Re: File No. NAE-2022 -01622 Becker Pond Dam Removal Project

This letter provides a narrative response to the request for additional information that your office issued on November 15, 2023. Please find the requested plan revisions attached to this letter.

Figure 1. Construction-period disturbance within the Existing Land Under Water

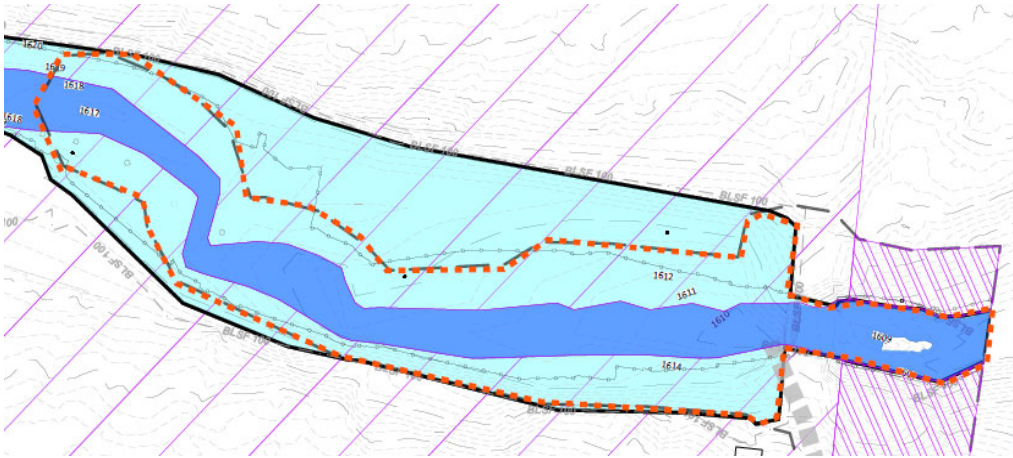
Question: *Please clarify impacts associated with the project. It appears that project plans indicate 70 sq. ft. of permanent fill impacts but the fill impacts are not mentioned within the project narrative. Please also confirm that the temporary construction impacts totaling 25,500 sq. ft. as stated within the narrative are accurate.*

The **temporary construction impact** to Land Under Water is approximately 25,500 square feet. This represents the area where the **Limits of Disturbance** overlap the **Existing Land Under Water**. In Figure 1, the red dotted line represents the boundary of the 25,500 square foot footprint. A polygon representing this footprint has been added to the revised sheet 3 of 6.

With respect to Figure 1 (above), the light blue/cyan shaded area outside of the Limits of Disturbance represents the footprint of permanent indirect impact associated with removing the dam and reverting to the historical Ordinary High Water level. The indirect impact will result in a conversion of the present day Land Under Water area to upland and floodplain.

Figure 2. Excerpt of Sheet 2, annotated with specific tree-clearing areas.

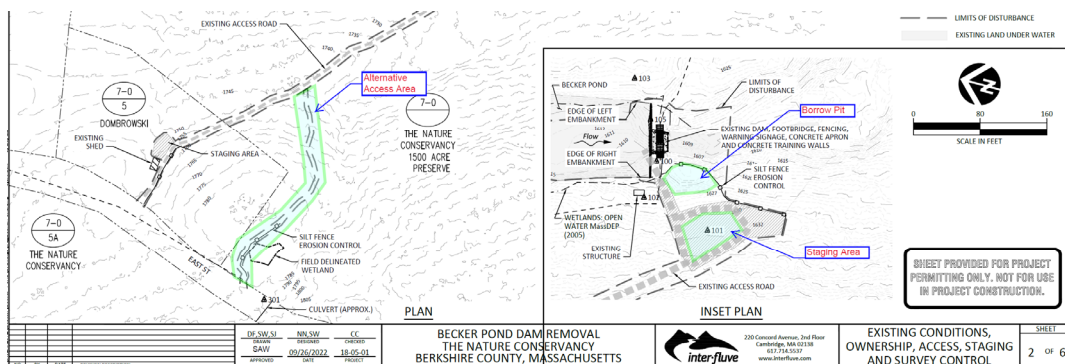
Question: Please provide the estimated area of tree cutting/clearing associated with the entire project, not just the area of waters where impacts are proposed. USACE requires this information to perform endangered species act (ESA) consultation with U.S. Fish & Wildlife Service for impacts to the ESA-listed northern long-eared bat.

Response: The estimated area of tree cutting is limited to three zones:

1. the alternative access route area,
2. the staging area adjacent to the dam, and
3. the borrow pit.

Refer to Table 2 and Figure 2 for a detailed summary of the areas. The location of the alternative access route was chosen to prioritize avoiding mature trees; however, some clearing of mature trees will be required.
